February 4, 2020

**Re: Response to DEP Comments for HDD Re-Evaluation Report
SPLP HDD No. S3-0300 Park Road Crossing
PADEP Section 105 Permit No.: E15-862
Upper Uwchlan Township, Chester County**

Mr. John F. Hohenstein P.E.
Response to DEP Comments on HDD S3-0300
February 4, 2020

Proposed Plan and Profile, rev. 3/14/19, showing IRs and geology

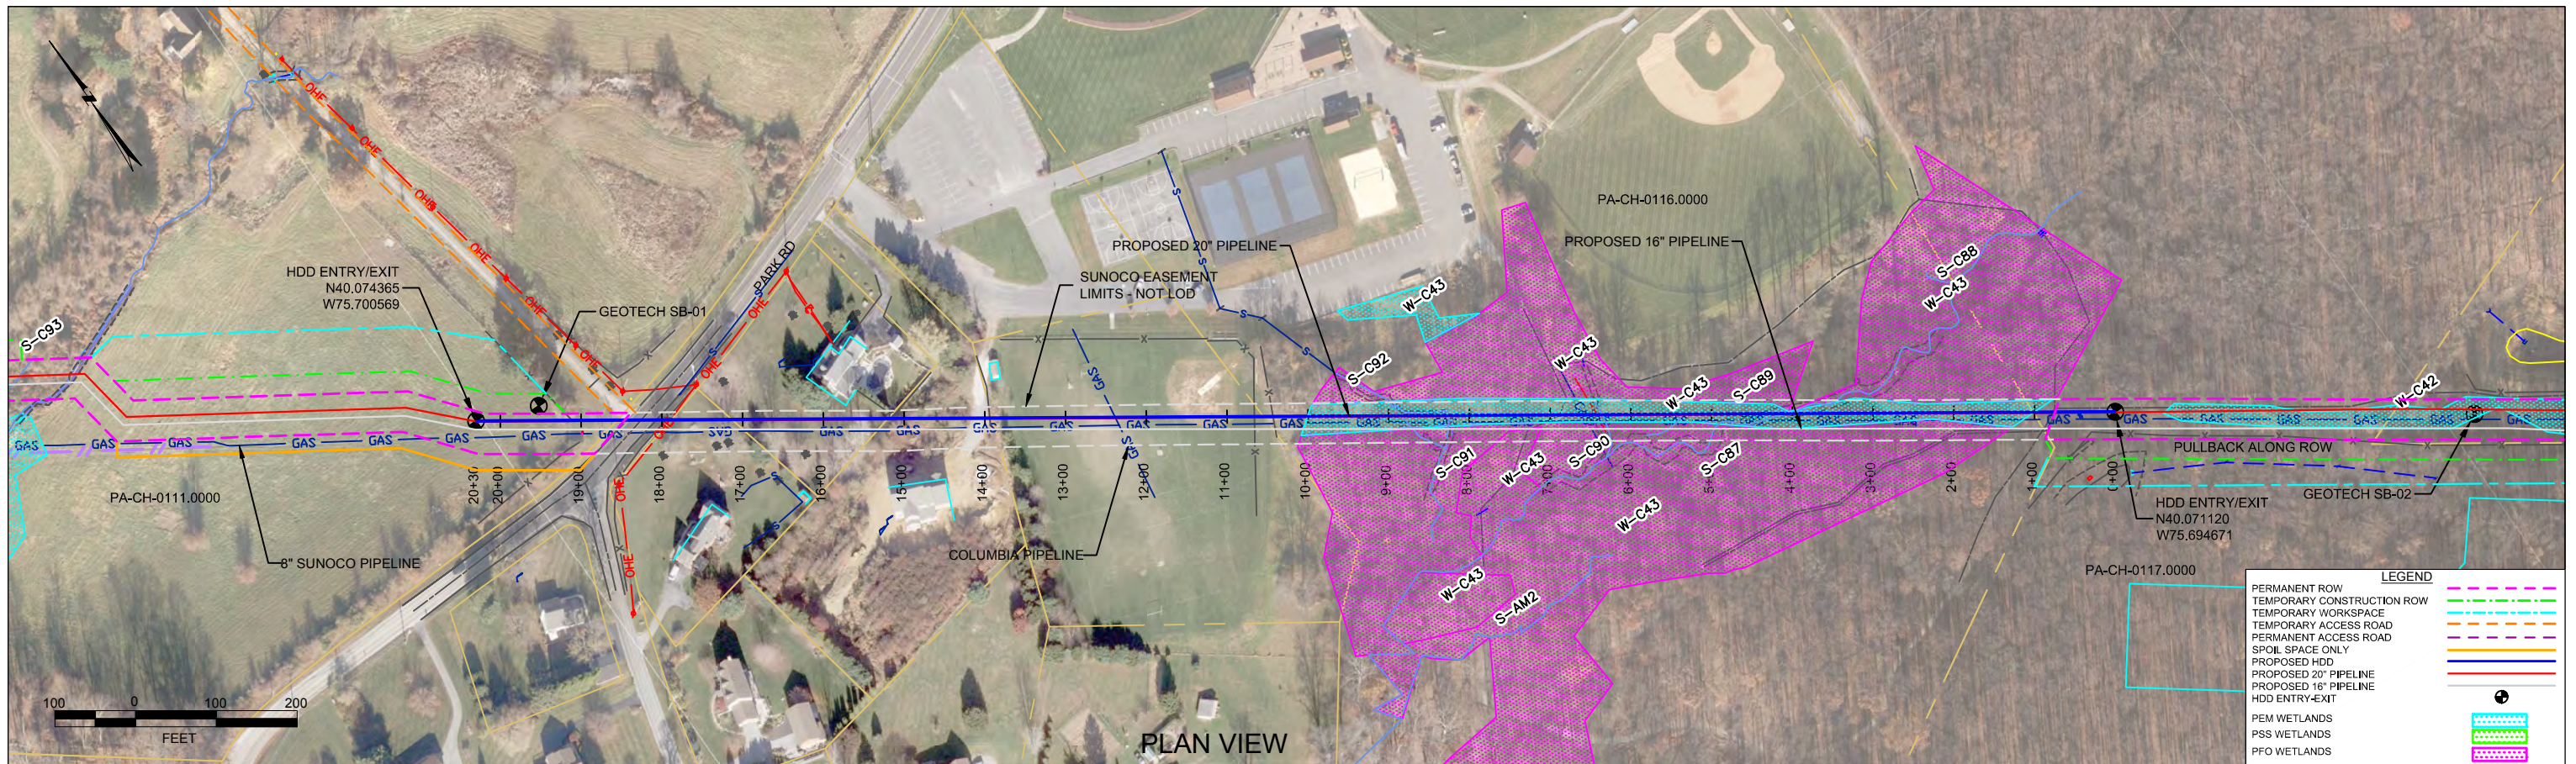
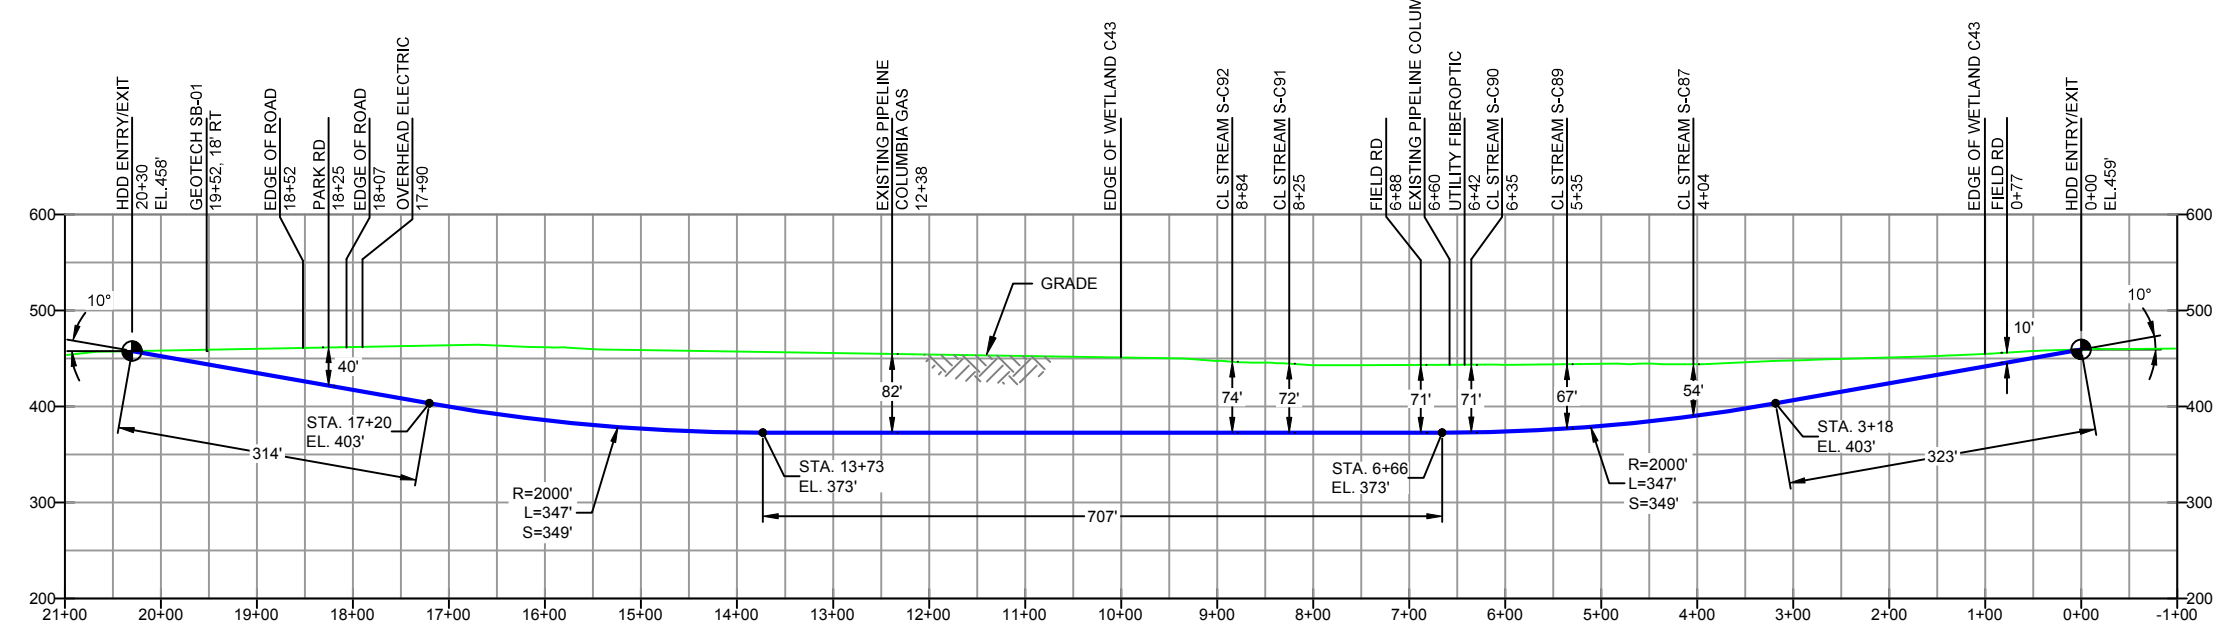
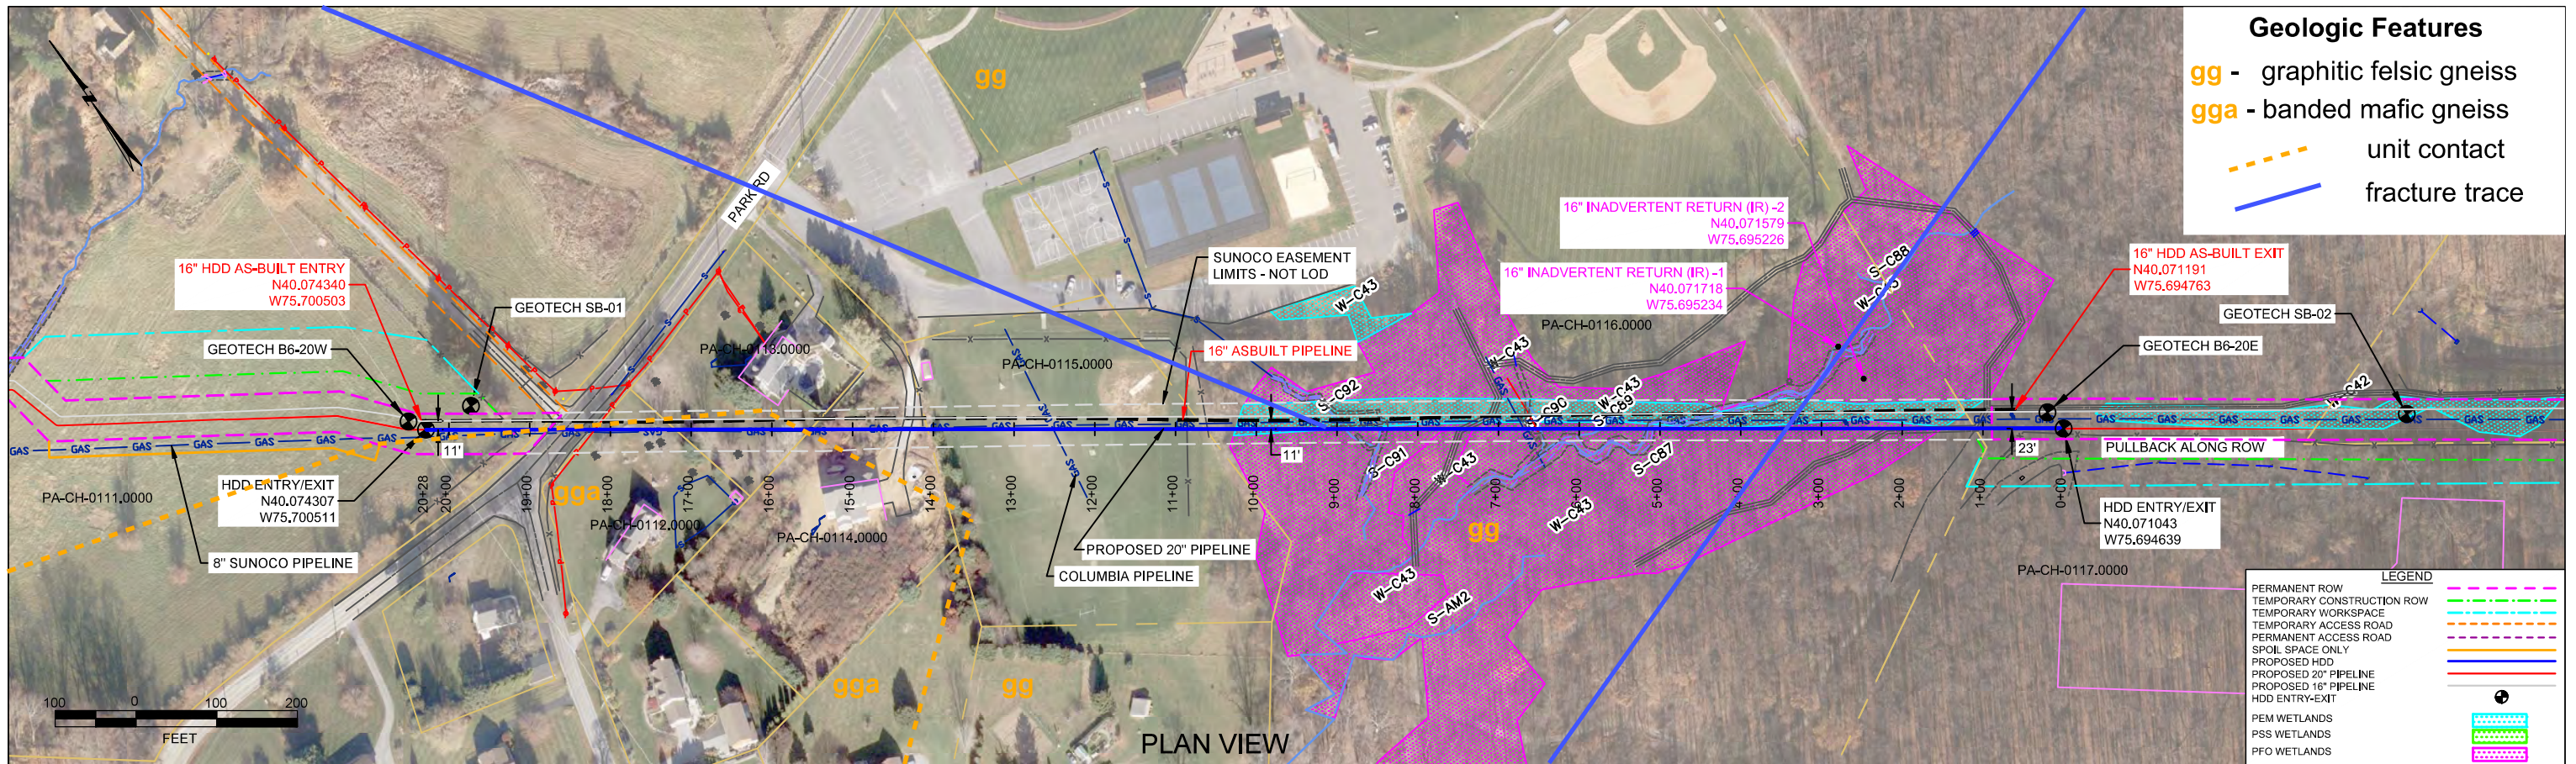
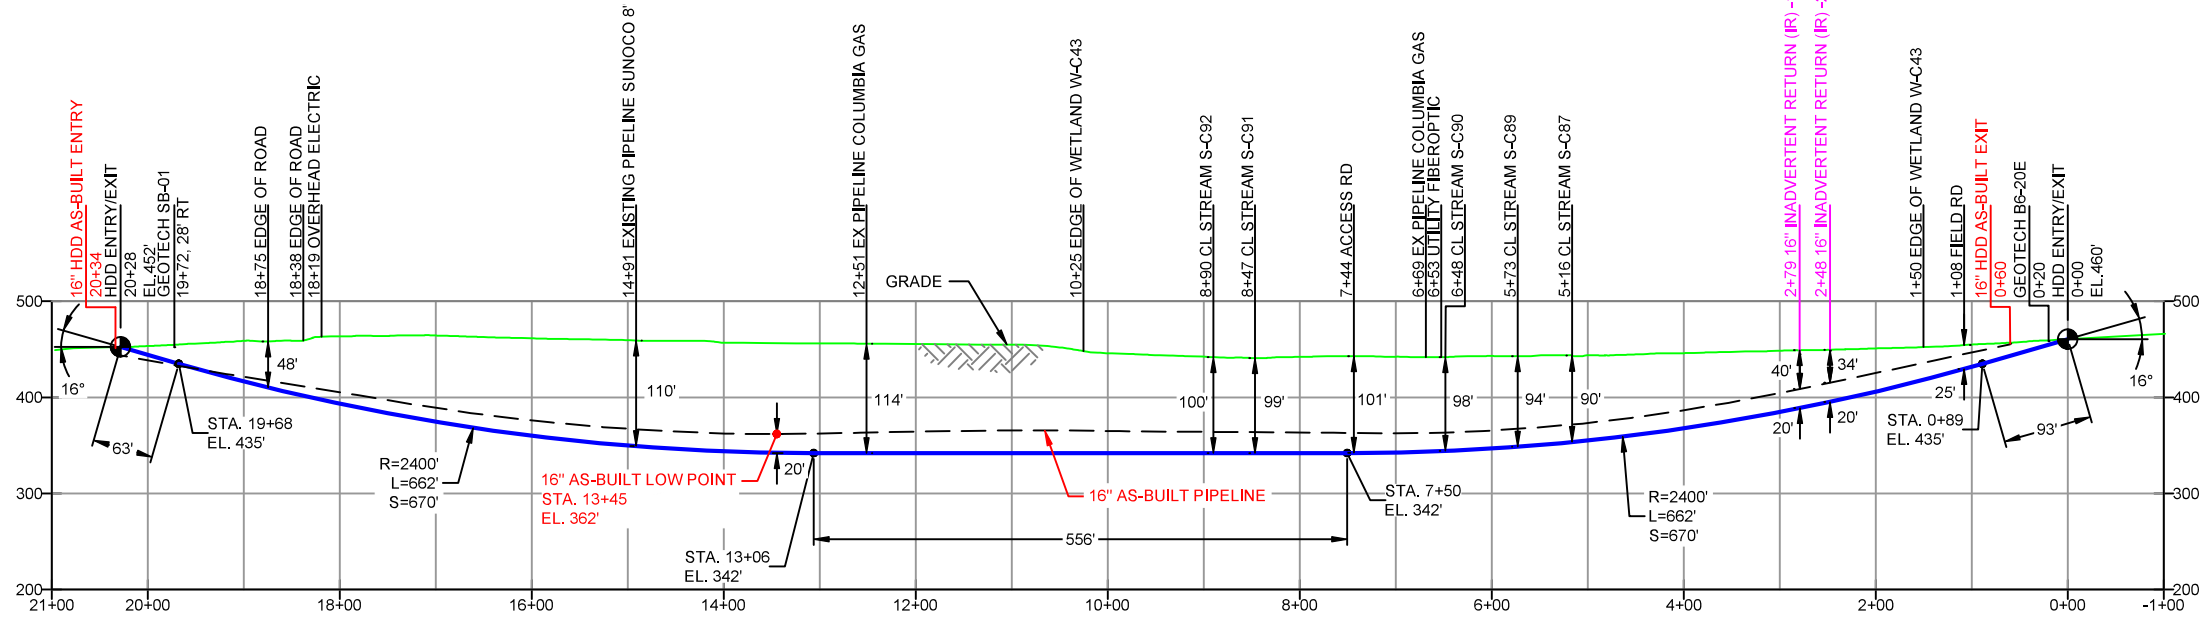
- 3. The eastern-most HDD entry/exit point at station 0+00 is located in between a PFO wetland and a PEM wetland. Details to prevent encroachment and/or damage to the PEM wetland east of the HDD entry/exit point during continuation of pipeline construction to the east were not provided. SPLP should provide justification for terminating the HDD**
